**Final Report
Six-Phase Heating Treatability Study
at the
Paducah Gaseous Diffusion Plant,
Paducah, Kentucky**

DE-AC05-03OR22980: Transmittal—Final Report Six-Phase Heating Treatability Study at the Paducah Gaseous Diffusion Plant, Paducah, Kentucky (DOE/OR/07-2113&D2)

COMMENT RESPONSE SUMMARY
Six-Phase Heating Treatability Study Final Report DOE/OR/07-2113&D1

Figure 2.1. Vapor Waste Stream Comparison, Photoacoustic and Summa Canister Data

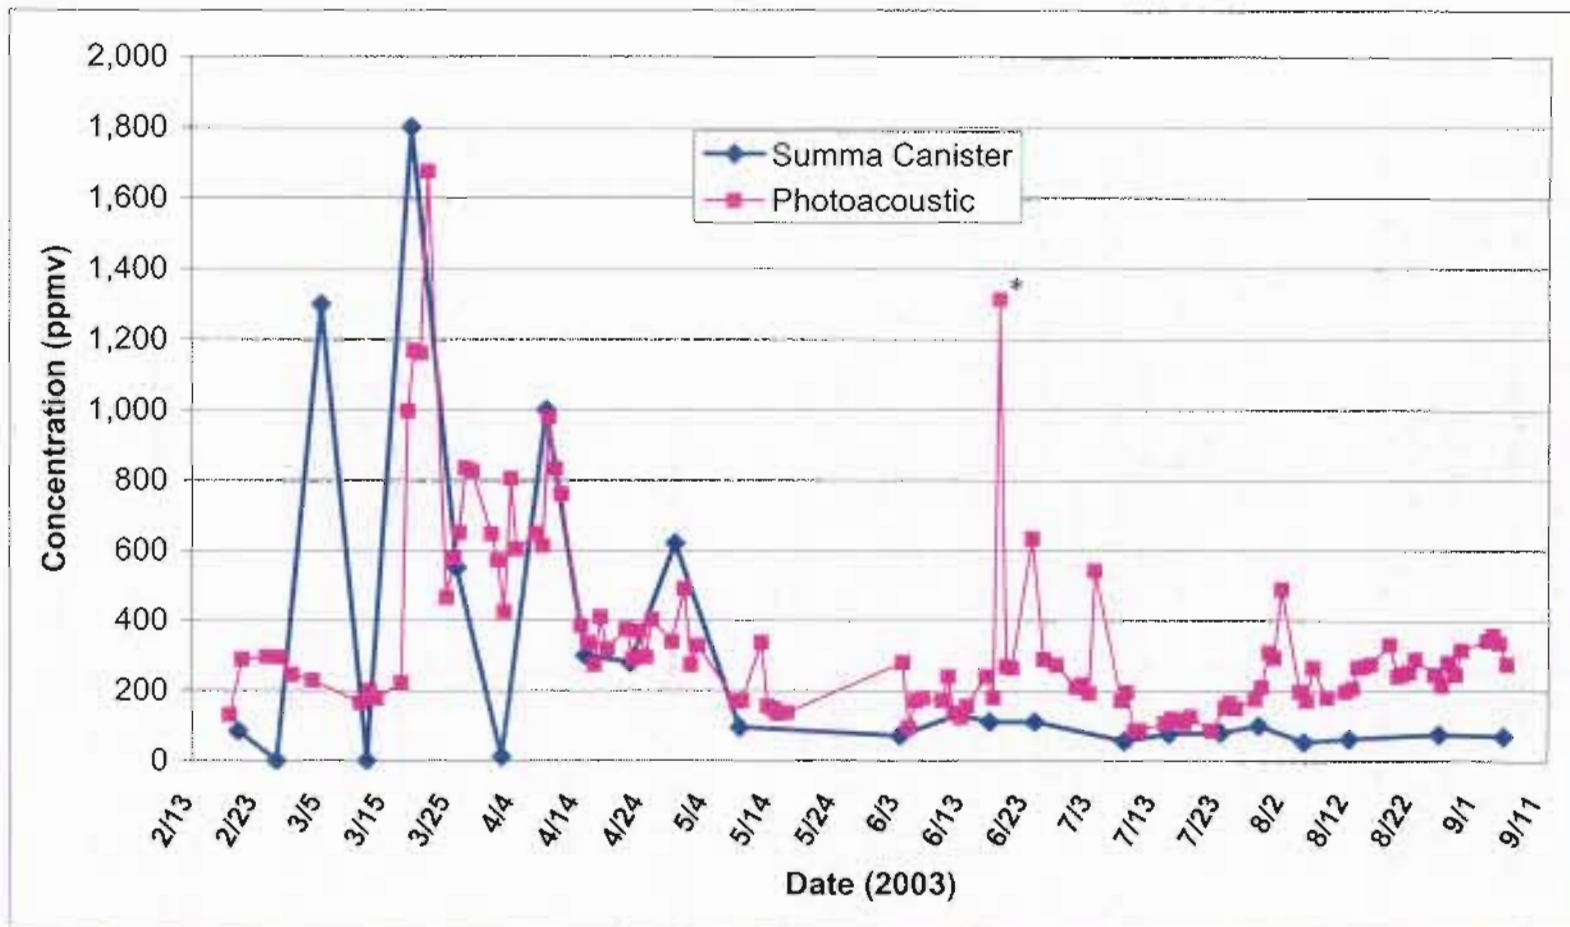
2	Section 2.1.2, Page 2-3, TCE Removal Rates as a Function of Operational Time and Energy Consumption	This paragraph discusses comparison of TCE removal rates using photoacoustic analyzer and summa canisters as presented in Figure 2.1. In this figure, an explanation is provided for the photoacoustic concentration spike measured on June 18, 2003. However, three additional photoacoustic concentration spikes are plotted in Figure 2.1 after June 18, 2003. This paragraph of the document, and/or Figure 2.1, should be revised to include explanations for the three post-June 18 photoacoustic concentration spikes.	Agree. Contaminant concentrations were measured with the photoacoustic analyzer once per workday. Summa canister samples were integrated once per week for a 24-hour sampling period. Contaminant concentrations could have varied greatly between sample periods with the photoacoustic analyzer. Additionally, contaminant levels often increased if the vacuum blower had been shut down for an extended period of time. However, a definitive explanation is not available for the additional spikes.

Figure 4.5. MW406 Temperature versus Depth

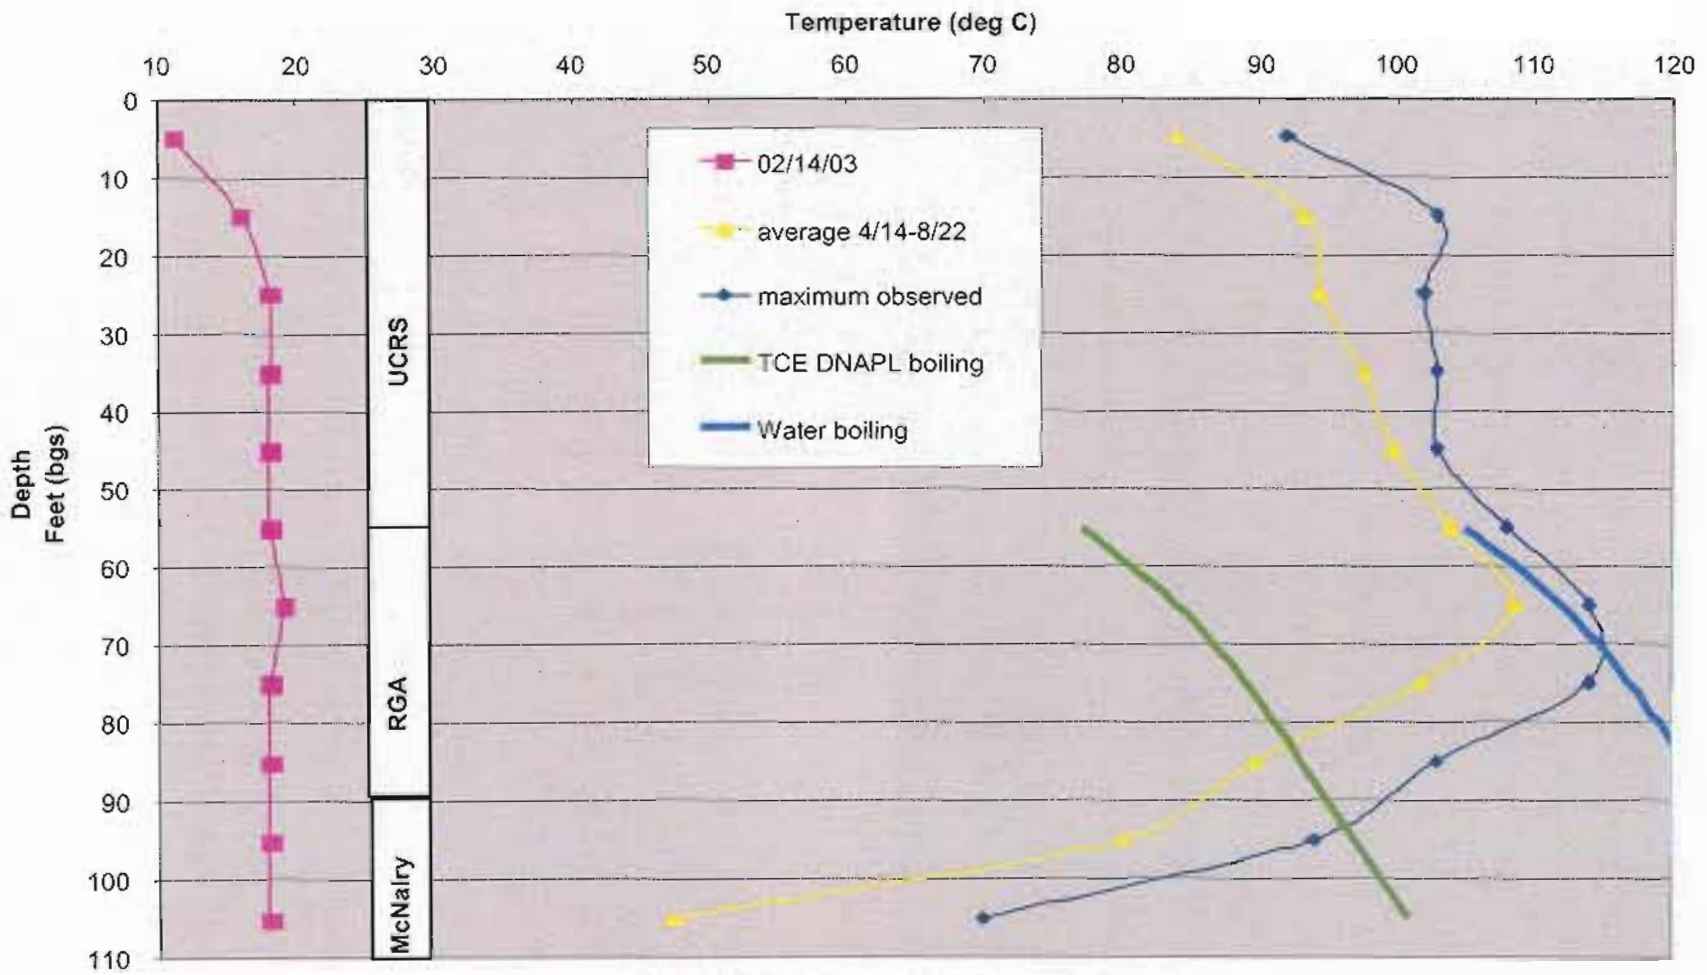
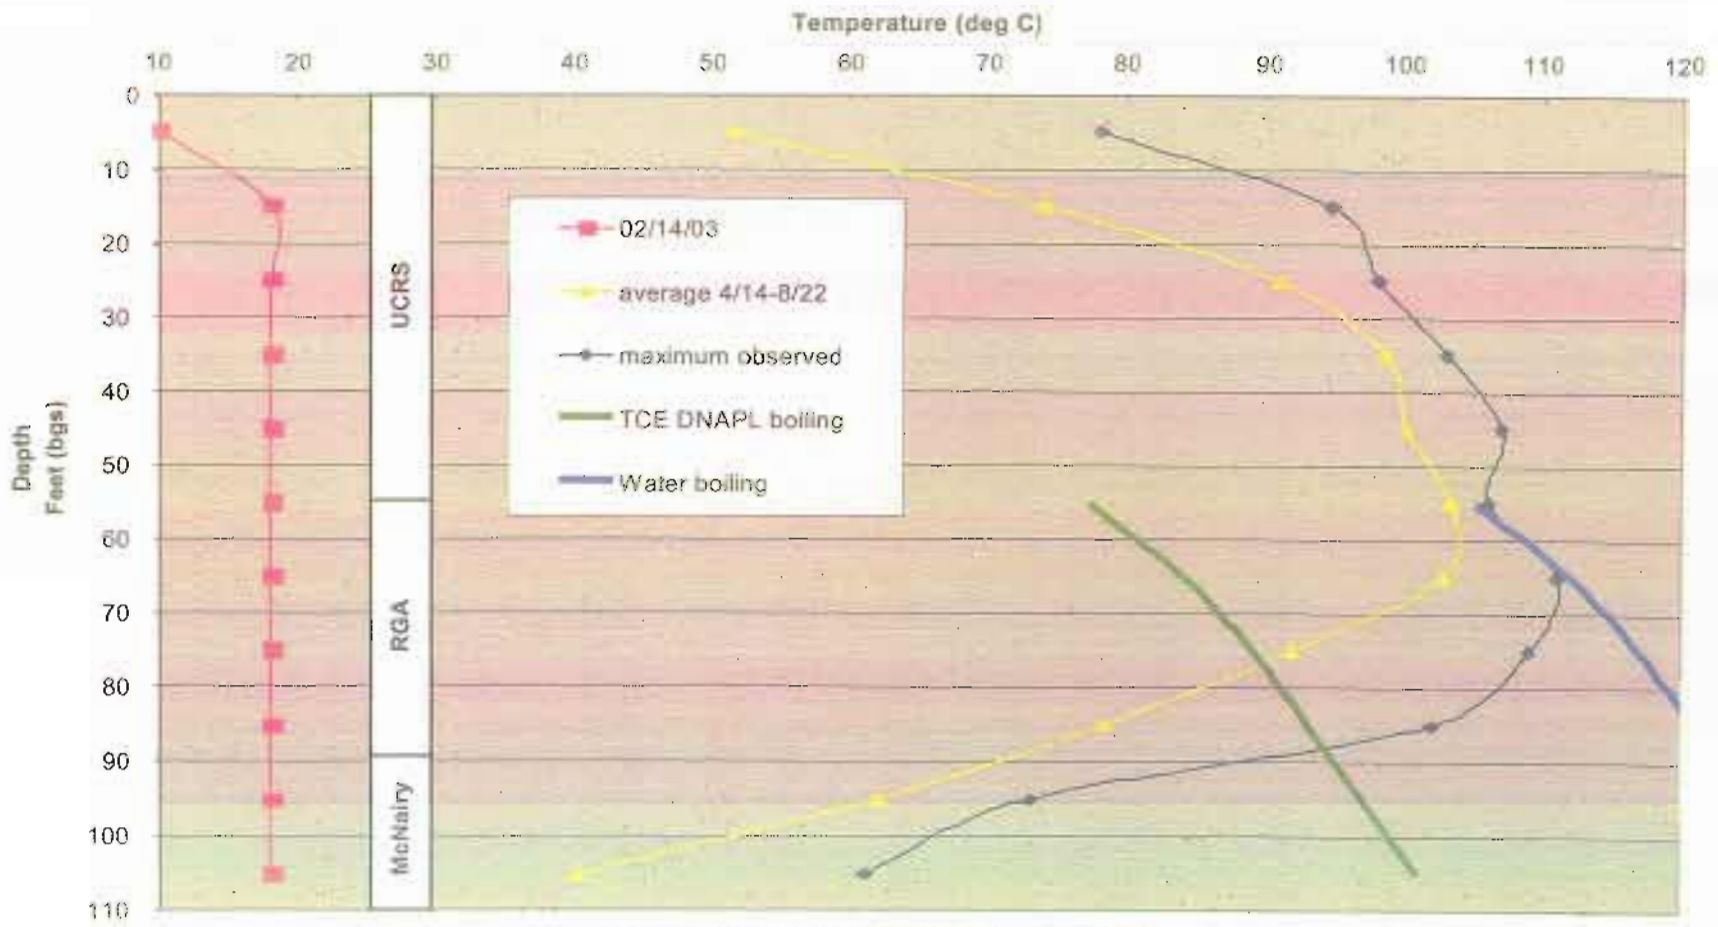
5	Section 4.1.2.2, Page 4-9, 1 st Paragraph	Near the end of this paragraph, reference is made to Figure 4.5 (graph depicting groundwater sampling results for MW406) and Figure 4.6 (graph depicting groundwater sampling results for MW407). The figure numbers for these graphs are incorrect and should be corrected to indicate that the MW406 graph is Figure 4.7 and the MW407 graph is Figure 4.8.	Agree. The figure numbers will be corrected.

COMMENT NO.	PAGE/PARAGRAPH/ SECTION	COMMENT	RESPONSE
6 (cont)		<p>The temperature versus depth data plotted in Figures 4.5 and 4.6 of the document for monitoring wells MW406 and MW407 was found to be as follows:</p> <p>Based on the information and data summarized above, the following is concluded:</p> <ul style="list-style-type: none"> <input type="checkbox"/> During the timeframe from January 10 through June 23, 2003, the baseline, 60%, and 87% groundwater sampling events were conducted for the study. <input type="checkbox"/> During the timeframe from April 14 through August 22, 2003, the average temperature in the 75 ft bgs depth interval at MW406 and MW407 was greater than 93°C and that the average temperature in the 85 ft bgs, 95 ft bgs, and 105 ft bgs depth intervals were less than 93°C. <input type="checkbox"/> During the course of the entire study, the maximum observed temperature in the 75 ft bgs, 85 ft bgs, and 95 ft bgs depth intervals at MW406 and MW407 were equal to or greater than 93°C and the maximum observed temperature in the 105 bgs depth interval was less than 93°C. <input type="checkbox"/> At no time during the study was the temperature of the 105 ft bgs depth interval ever increased to greater than 93°C. <p>The TCE sample concentration data plotted in Table 4.1 of the document for monitoring wells MW406 and MW407 was found to be as follows:</p>
